Administrative Approval Action

Case File / Name: SUB-0028-2022
DSLCL - SUNNYBROOK ROAD TOWNHOMES

REQUEST: Development of a R-6 zoned, 1.83 acre/79,748 sf tract into proposed 18 lots, 17 multi-units (townhomes) residential lots and 1 HOA maintained Common Lot. A total right-of-way dedication of .02 acres/952 sf leaving a net area of 1.81 acres/78,796 sf for the site.

CITY OF RALEIGH SUBMITTAL
SUB-0028-2022

DATE: 03/04/2024
DRAWN BY: JMM
CHECKED BY: JMM
PROJECT: SUNNYBROOK ROAD TOWNHOMES
SHEET NO. C3.00

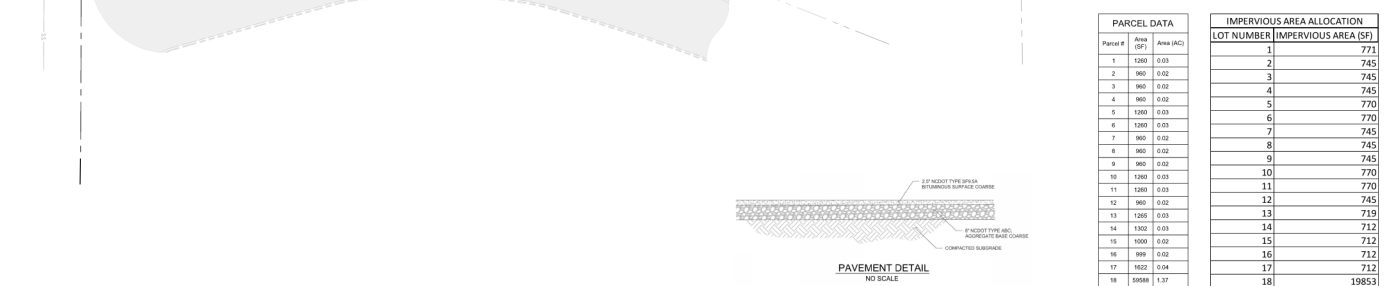
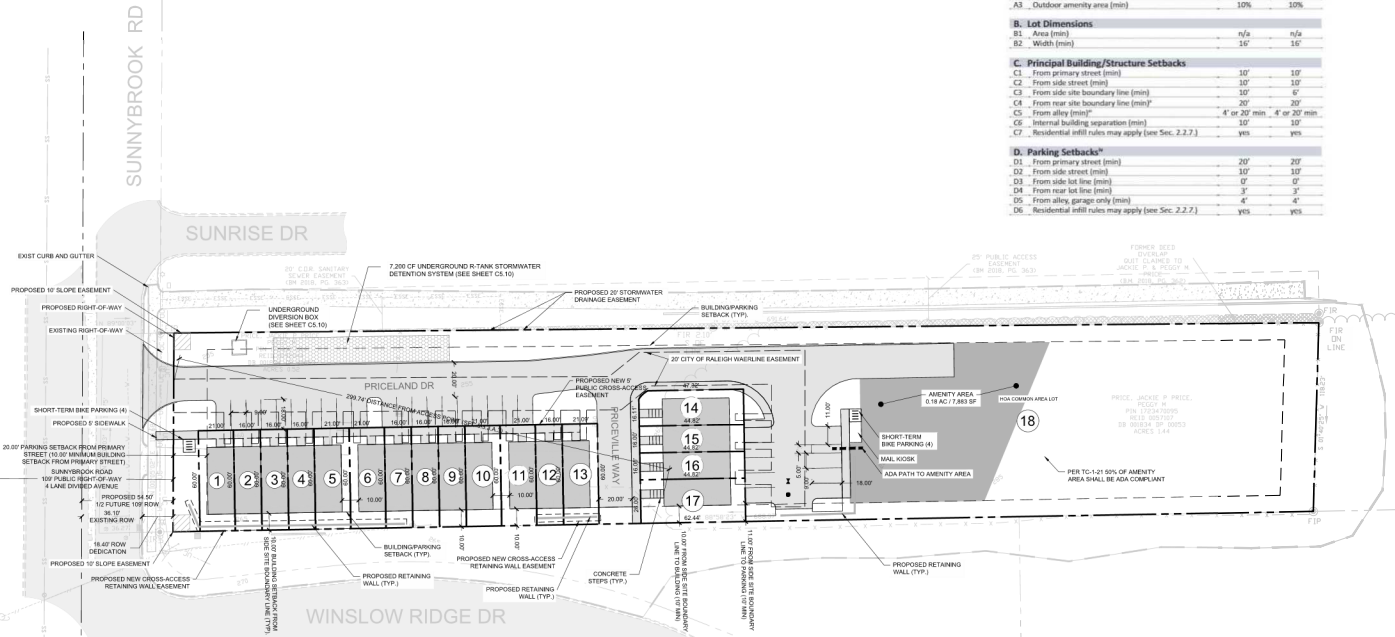
1. Applicant revises the density townhome data table, shown on sheet C3, for the 'provided' area sf.
